SERVICE BULLETIN

Classification: EL18-017a	Reference: NTB18-057a	Date: August 17, 2018
------------------------------	--------------------------	--------------------------

2018 LEAF; MALFUNCTION AND AEB WARNING LIGHTS ON

This bulletin has been amended to update the color of the distance sensor mounting tab to yellow. Please discard all previous versions of this bulletin.

Figure 10

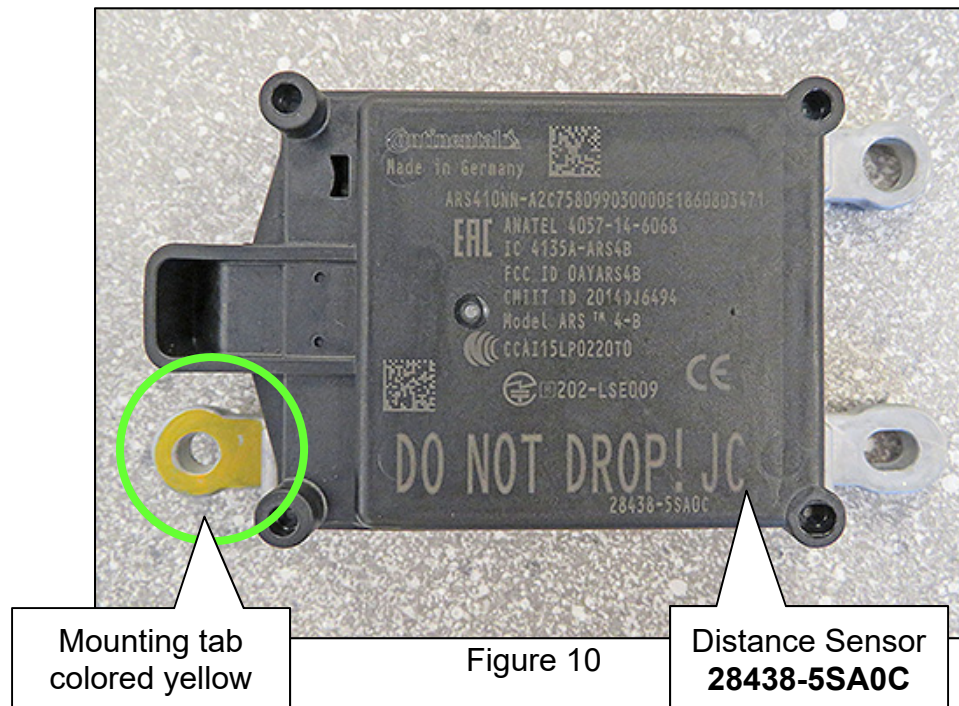
- New Distance sensor will have mounting tab colored **yellow**, as shown in Figure 10.
- Sensor is shown uninstalled and is for reference only.
